HISTORIC DISTRICT COMMISSION

Special meeting

- A. Certificate of Appropriateness Application: **320 B W. Orange St.** – New construction house on the rear parcel (PIN 9864882685)

ITEM #5. A:

- Front Elevation

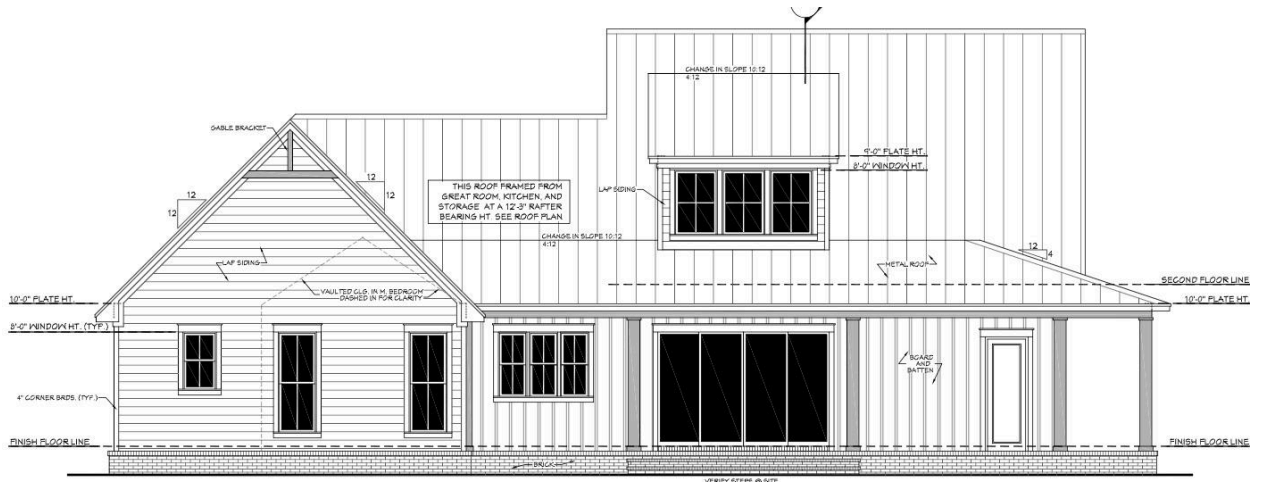
- The electronic version of the front elevation is difficult to read, and staff advised the applicant to submit a higher-resolution version.
 - The side elevations were split from a combined elevation into two separate elevations, but the fenestration plans for the west elevation and open area on the east elevation still need to be clarified.
